Application Number: 09/838,5
Reply to O.A. of August 27, 2004

AMENDMENTS TO THE DRAWINGS

Fig. 1

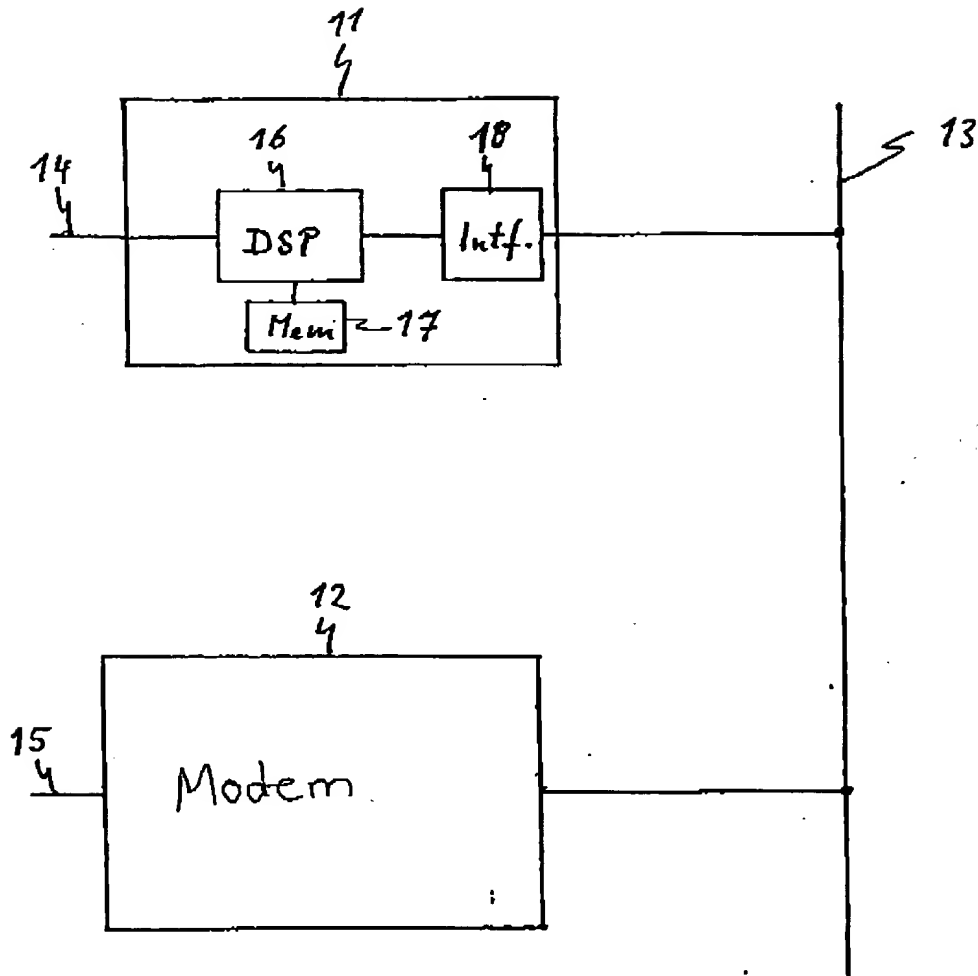
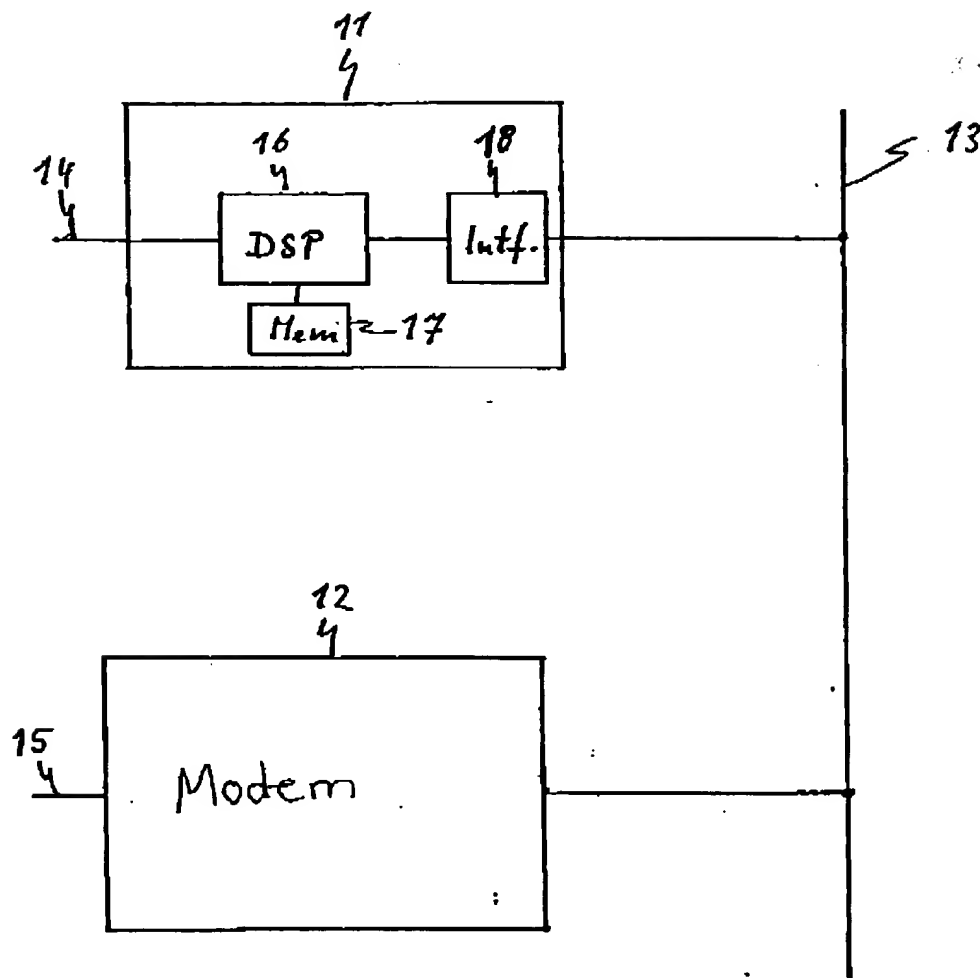
The attached sheet of drawings includes changes to Fig. 1. This sheet replaces the original sheet including Fig. 1. In Figure 1 the term "Modem" is added in block 12.
